**Municipal Services Center, Council Chamber
3600 Tremont Road**

Subject: 4190 Greensview Drive (#26-1672) - Informal review of a proposed home gym that exceeds maximum height and setback requirements for detached habitable spaces.

Subject: 2471 Westmont Boulevard (#26-1658) - Update to the Board on a preliminary concept for a three-story mixed-use building.

Subject: 2082 Fontenay Place (OR-xx-26, VAR-24-26) — Review of a plat amendment and variance to permit the retention of swimming pool decking and a patio that was installed without a permit and is located within the rear yard, which is prohibited.

FOUNDATION PLAN
3/8" = 1'-0"

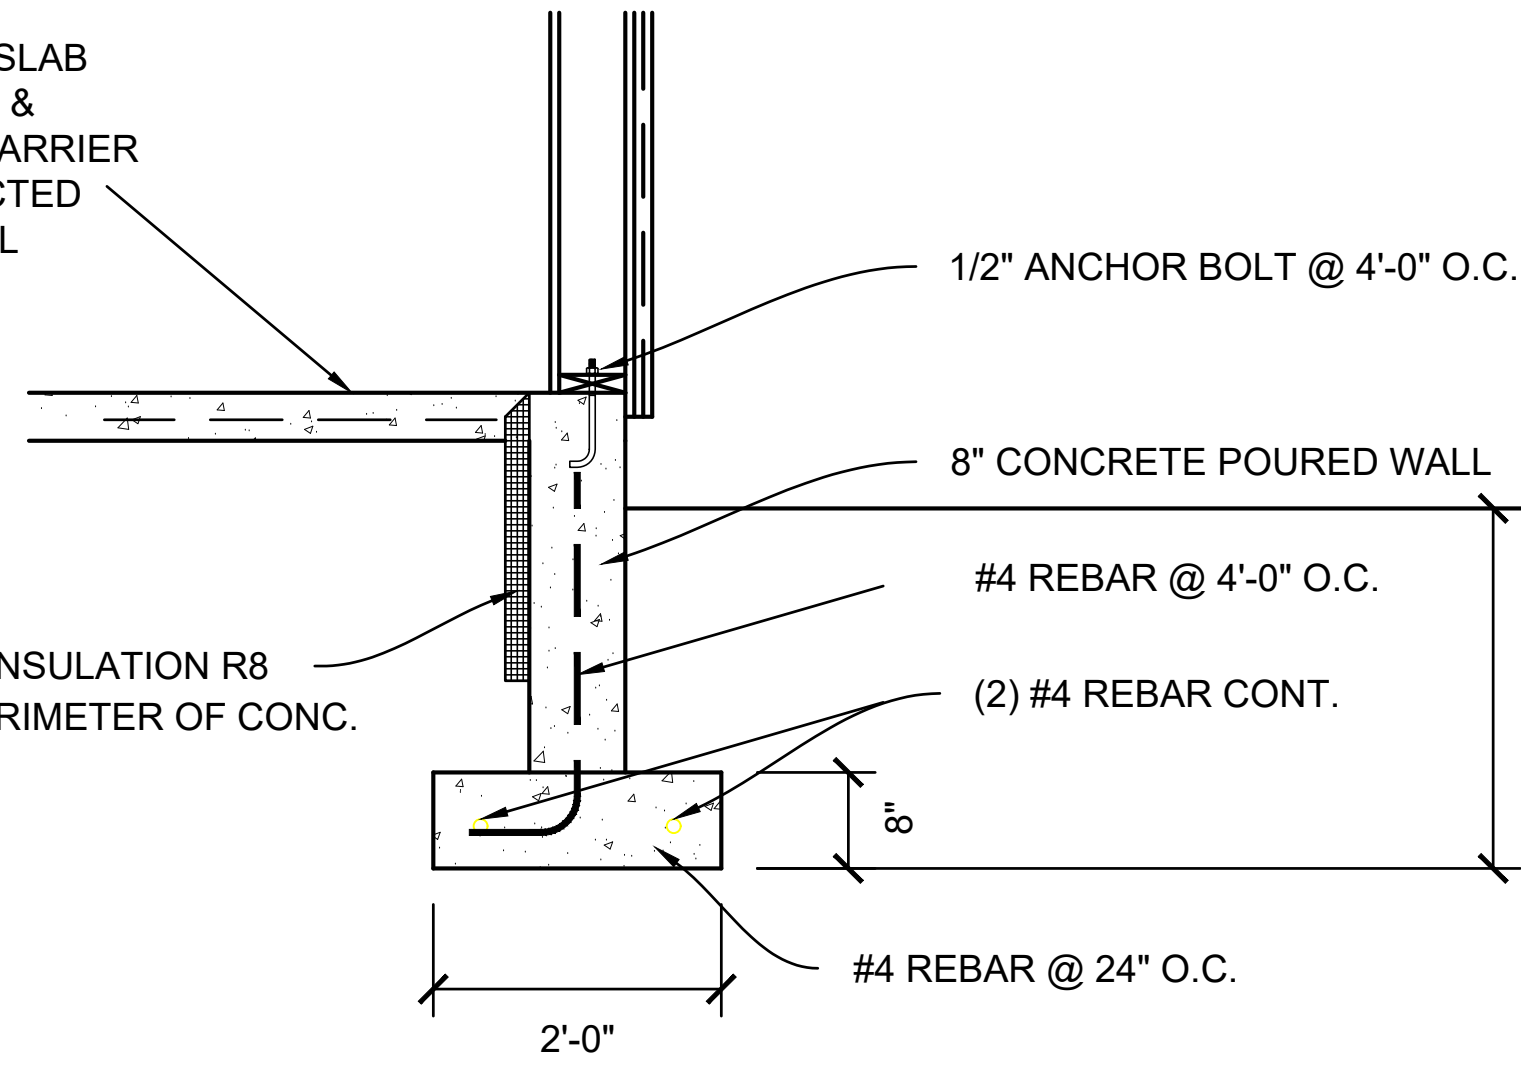
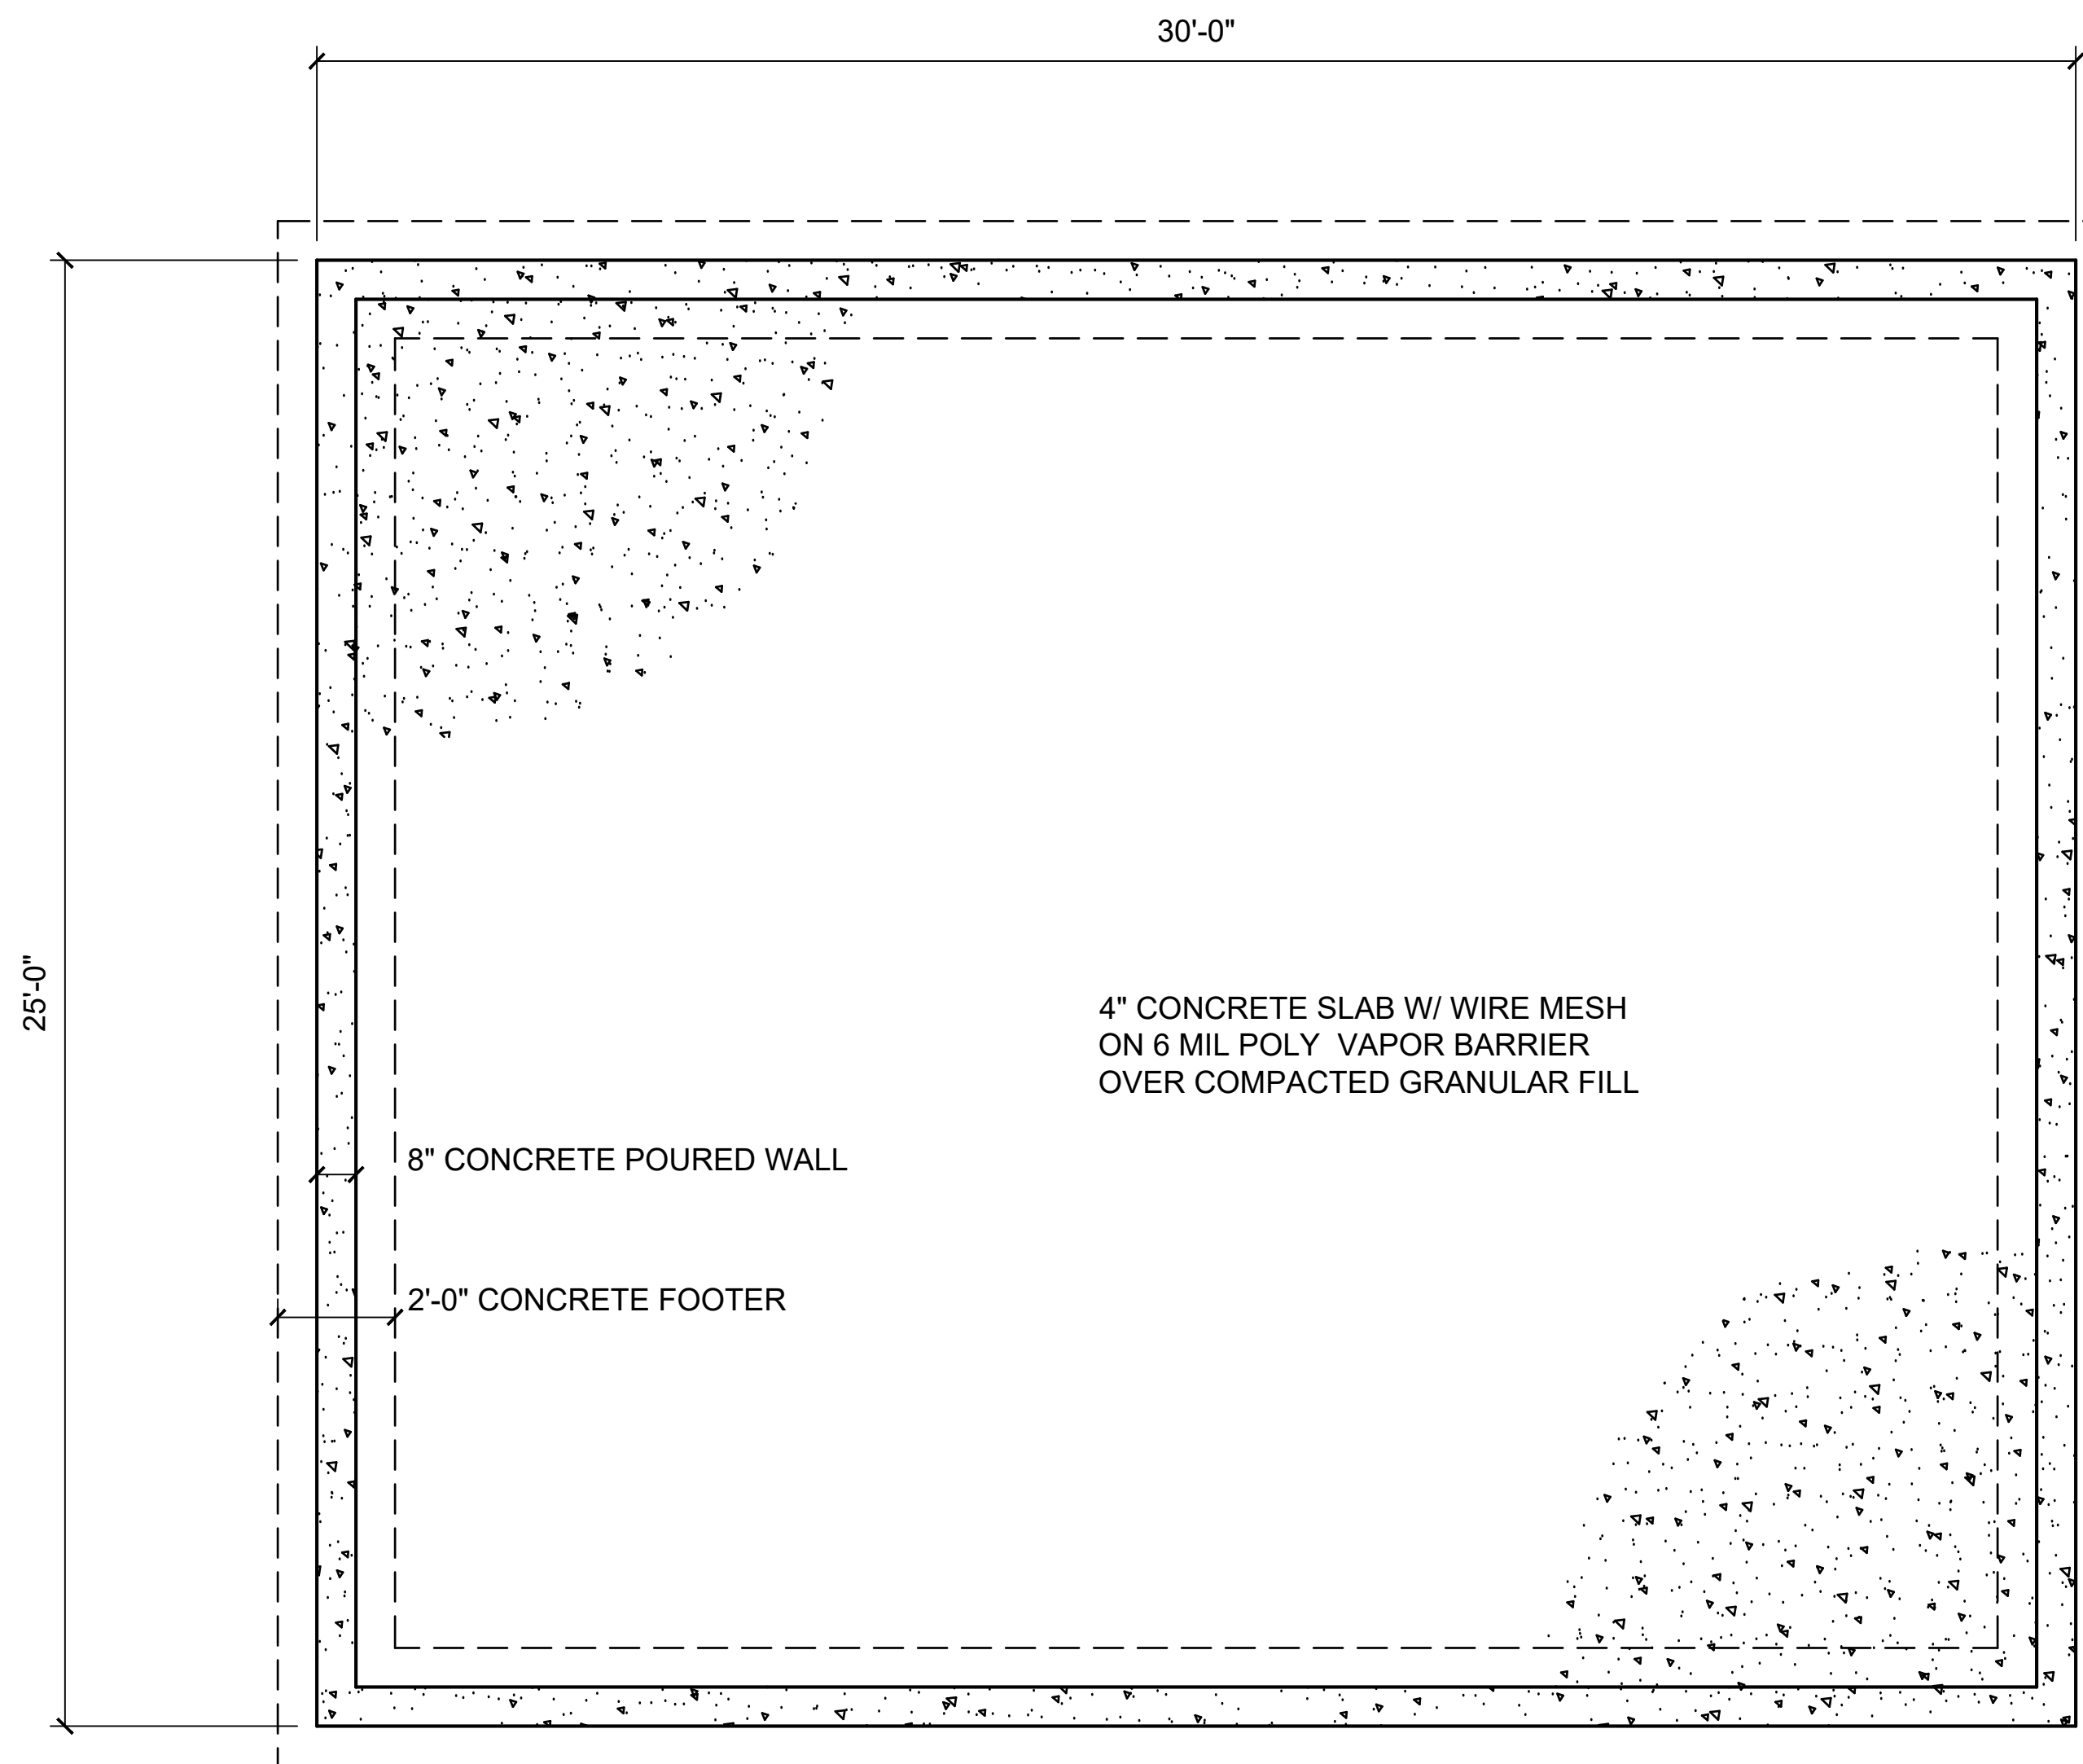
- Consider other possible locations which limit potential impacts on adjacent property. *[For reference, recreational structures require a 12-foot setback from property lines, but detached home gyms need to be located in the buildable area, in this case a 12-foot minimum side yard and a 40-foot minimum rear yard.];*
- Consider reducing the overall square footage of the structure, as 750 square feet is large and above the code permitted maximum (658 square feet);
- Consider reducing the height of the structure below 15 feet. *[Staff could see some support for a structure with a skewed roof, reaching from 10 feet to 12 feet in height, which would match the maximum height for a recreational structure.]; and*
- Consider removal of the concrete expansion area from the proposal and provide development cover calculations, as it appears the property is near the 40% maximum in the R-1b District.

- To permit an increase in height from 10 feet to up to 15 feet;
- To permit an increase in the accessory building coverage limit from 3 percent to 3.4 percent;
- To permit a reduction in the side yard setback from 12 feet to 10 feet;
- To permit a reduction in the rear yard setback from 40 feet to 10 feet; and
- To permit an increase in the 40 percent maximum development cover in the R-1b District (*coverage calculations pending*).

Proposed Site Plan

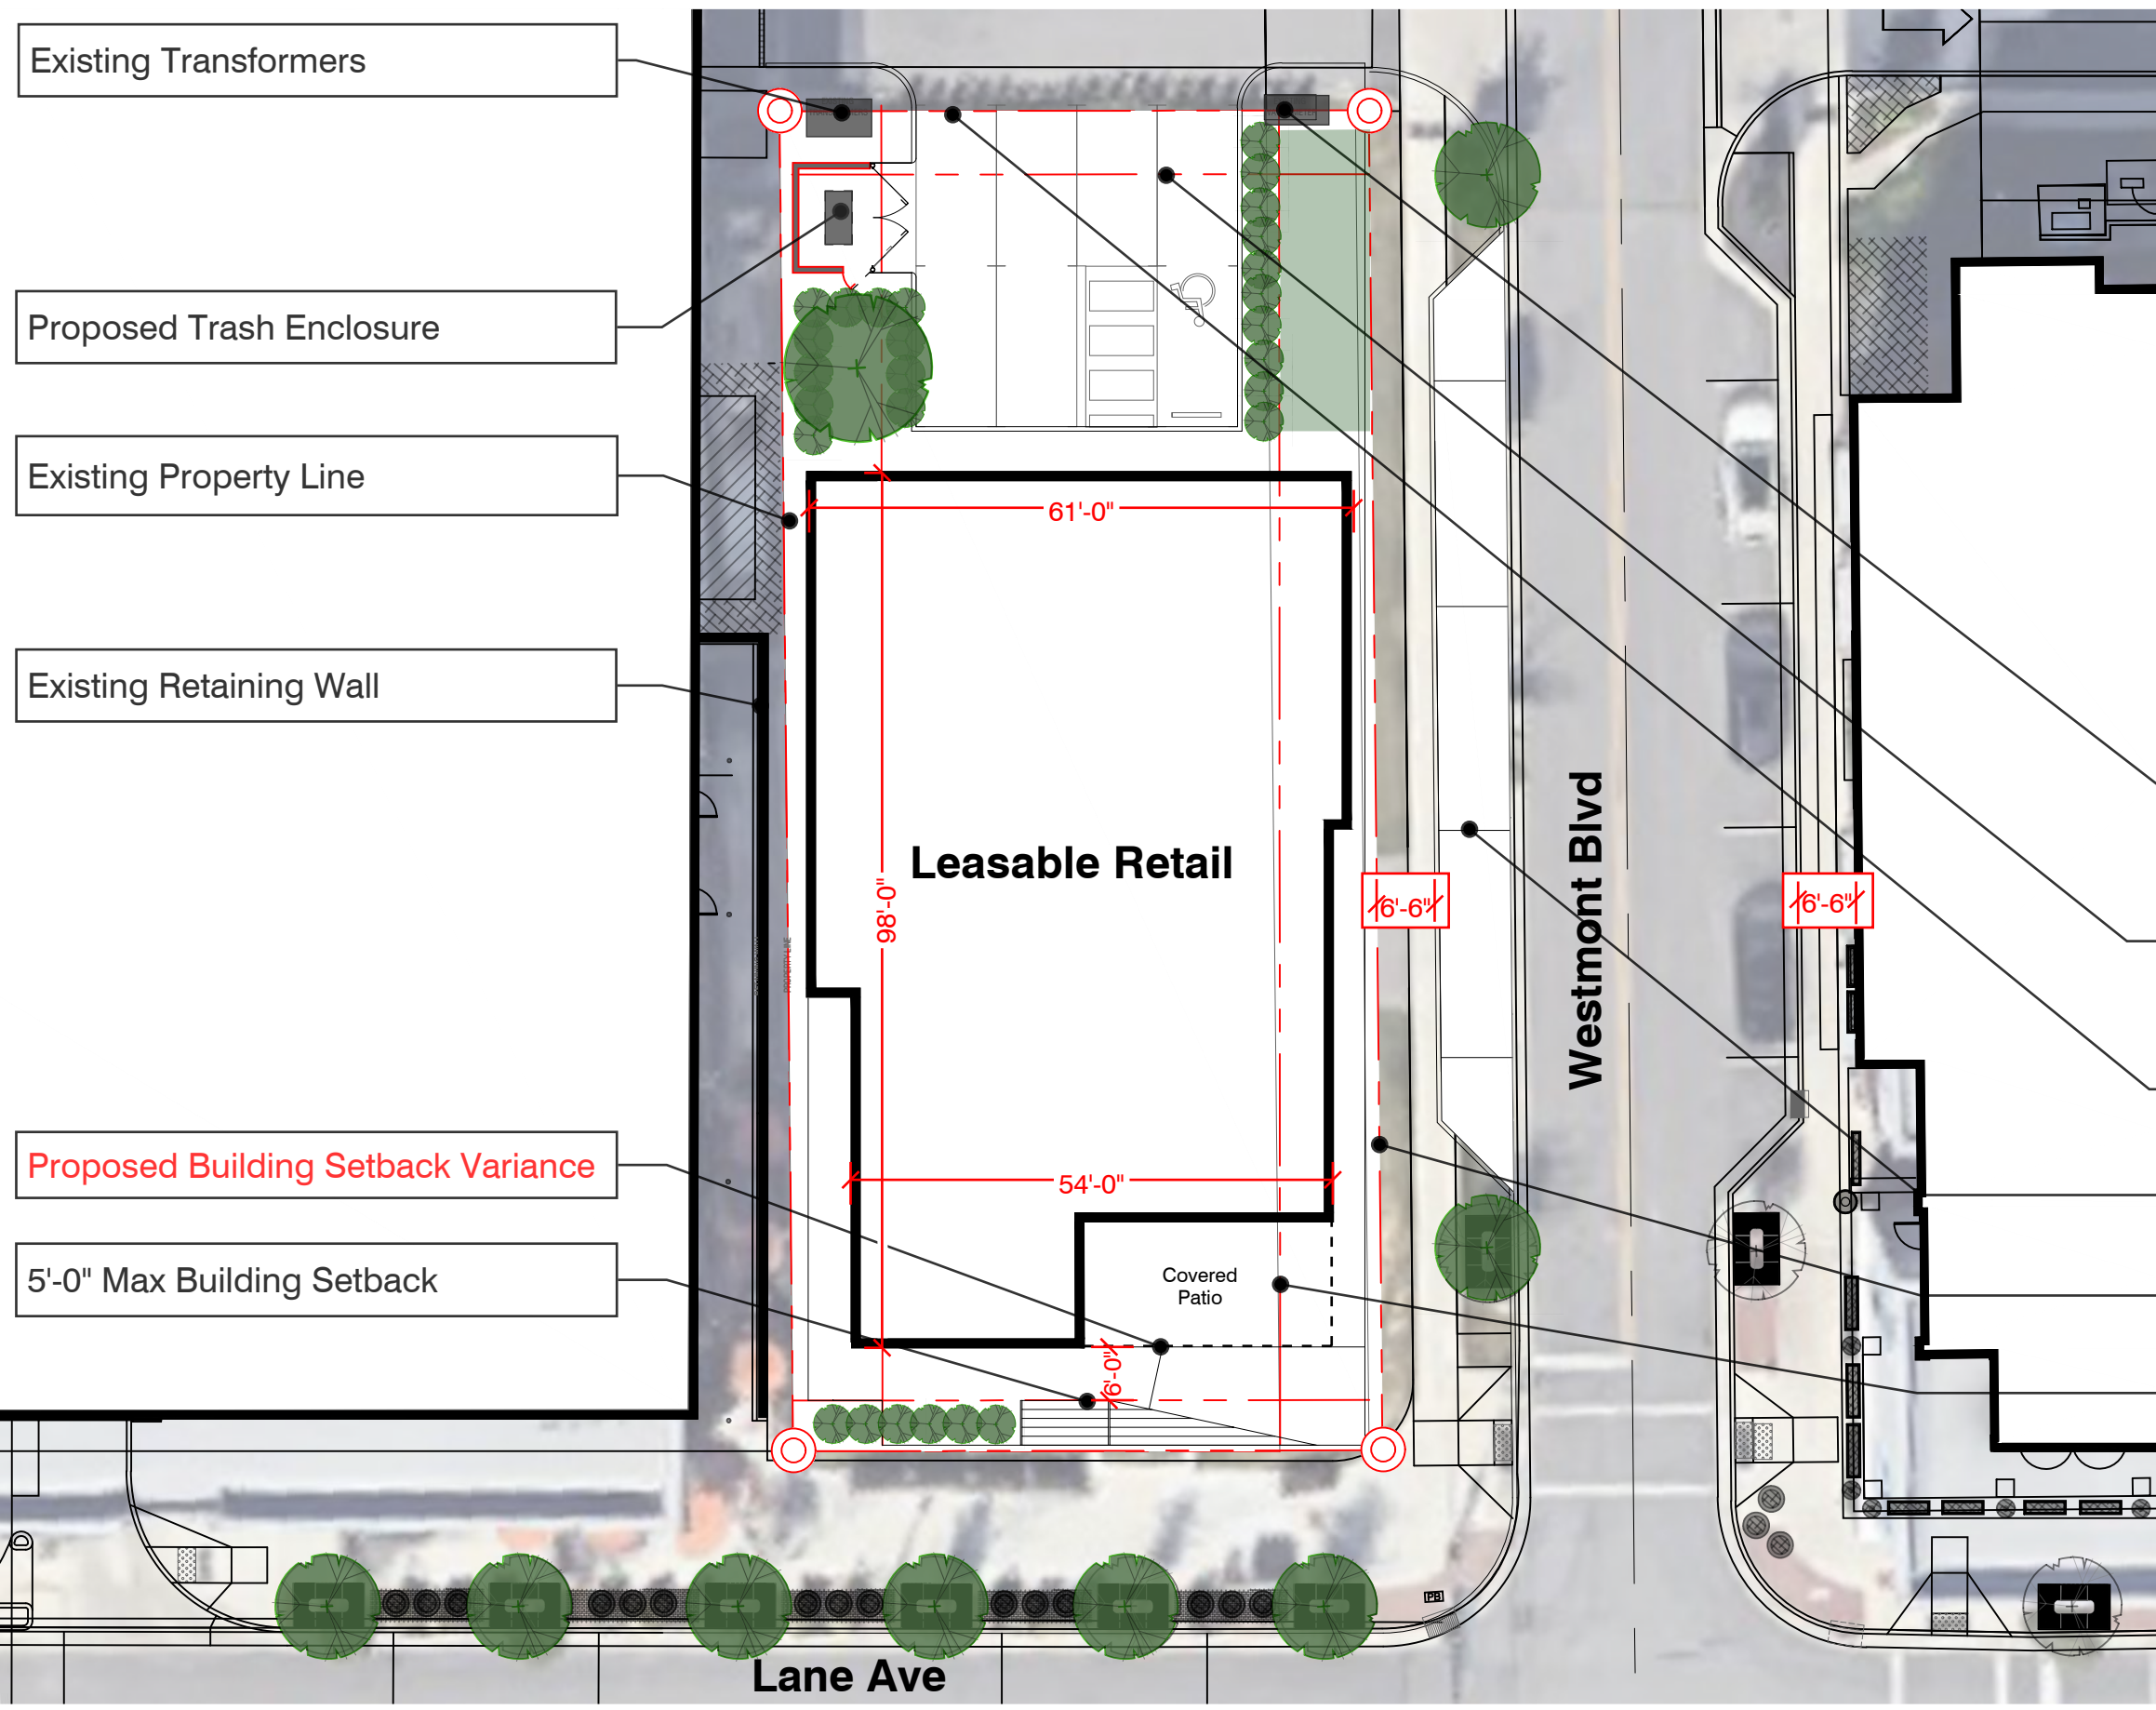
- The public/private plaza along W. Lane Avenue was removed; the building was moved closer to W. Lane Avenue and includes a first floor covered patio, a second floor balcony, and a third floor open-air balcony within the building's footprint.

- Parking spaces on the west side of Westmont Boulevard are noted as a valet/ride-share/loading zone.
- The north side of the property is identified with a trash enclosure and three parking spaces.

- To permit an increase in the building setback from the W. Lane Avenue curb from 30 feet to 32 feet;
- To permit a decrease in the building setback from Westmont Boulevard curb from 15 feet to 10 feet;
- To permit a zero setback for parking spaces on the north side of the site, in lieu of the 10-foot minimum rear setback; and
- To permit a reduction in the minimum number of parking spaces from 51 to six (provided on- and off-site).
